## **ELIZABETH PLATT ESTATES SUBDIVISION**

APPLICATION NUMBER 16 DATE April 17, 2008

REQUEST Subdivision

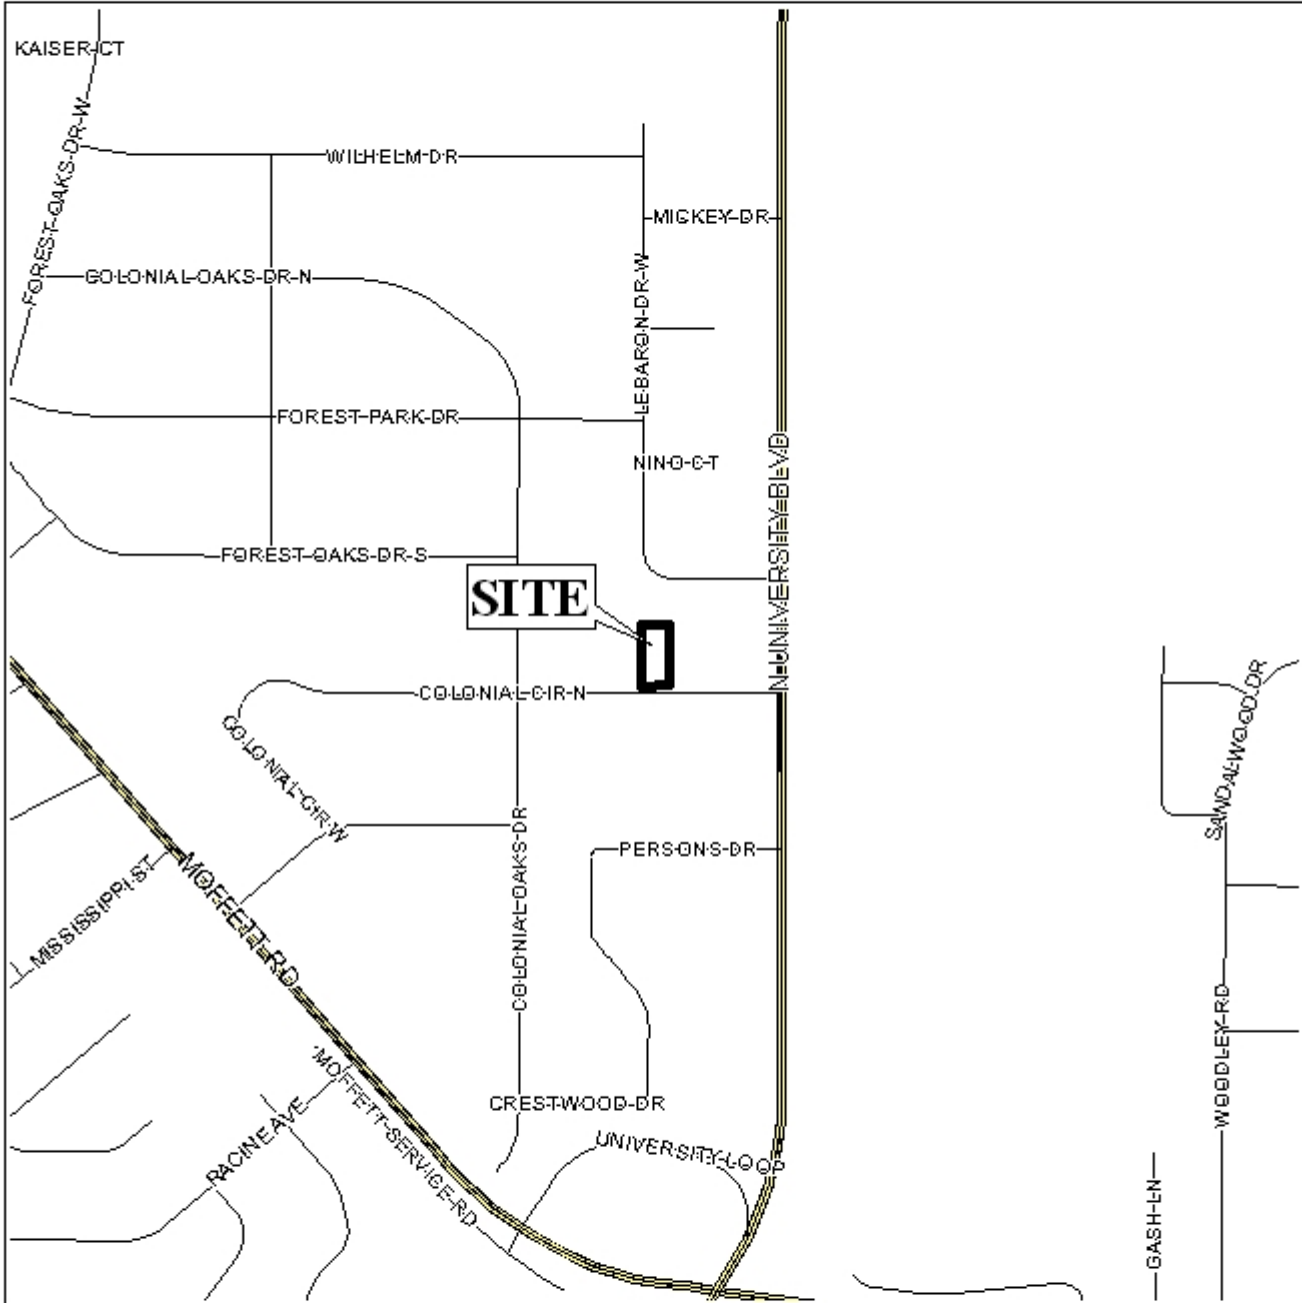
The proposed lot has frontage on Colonial Circle North with a compliant 50' right-of-way, therefore, no dedication is required. As a means of access management, a note should be required on the final plat limiting the lot to one curb cut to Colonial Circle North, with the size, location, and design to be approved by Traffic Engineering and conform to AASHTO standards. The plat illustrates a 25' minimum building setback line along Colonial Circle North and this should also be shown on the final plat.

The lot is labeled on the plat with its size in acres and square feet, and should also be labeled with such on the final plat, or a table should be provided furnishing the same information.

- 1) placement of a note on the Final Plat stating that Lot 1 is limited to one curb cut to Colonial Circle North, with the size, location, and design to be approved by Traffic Engineering and conform to AASHTO standards;

- 2) illustration of the 25' minimum building setback line along Colonial Circle North;
- 3) labeling of the lot with its size in acres and square feet, or the provision of a table on the plat furnishing the same information;
